**Amendments to the Drawings:**

*Application Serial No.: 10/768,150*  
*Art Unit: 3751*

*Attorney Docket No. 24024.00*  
*Confirmation No. 6427*

*Fig. 2*

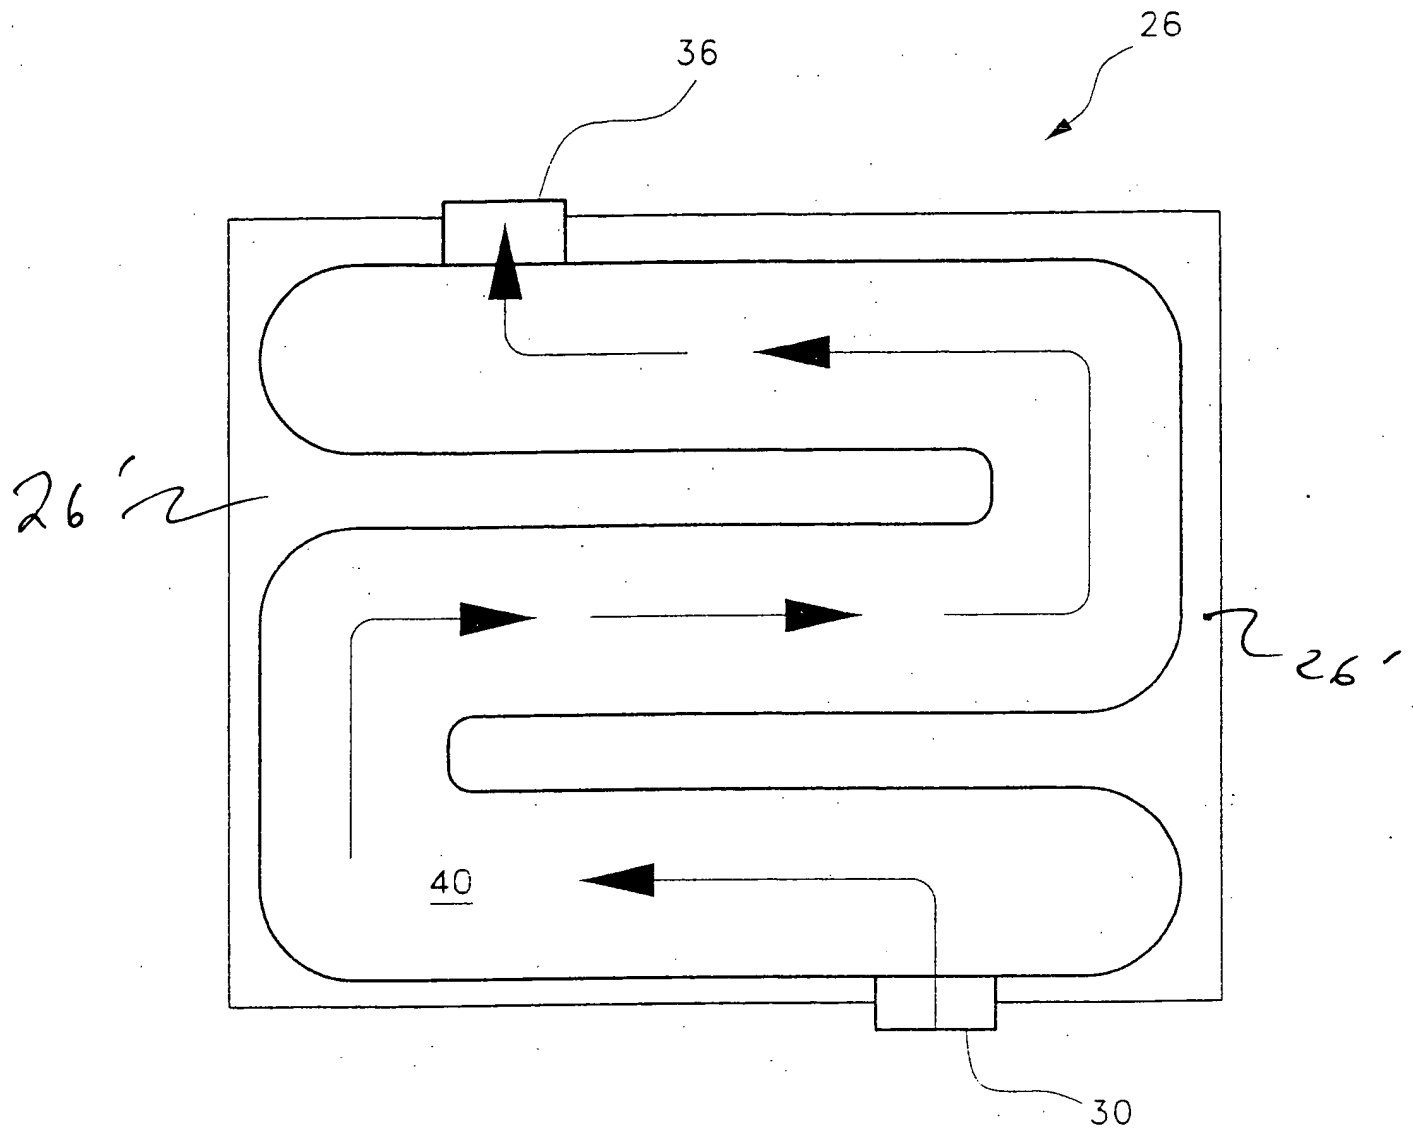
A proposed drawing change is submitted herewith. Proposed changes are shown in red. The attached sheet of drawings includes changes to Fig. 2. This sheet, which includes Fig. 2, replaces the original sheet including Fig. 2. In Fig. 2, previously omitted reference character -- 26' -- has been added.

Applicant has amended the specification to further describe the internal serpentine configuration of the storage tank, as shown and described in Fig. 2. Applicant submits that no new matter has been entered.
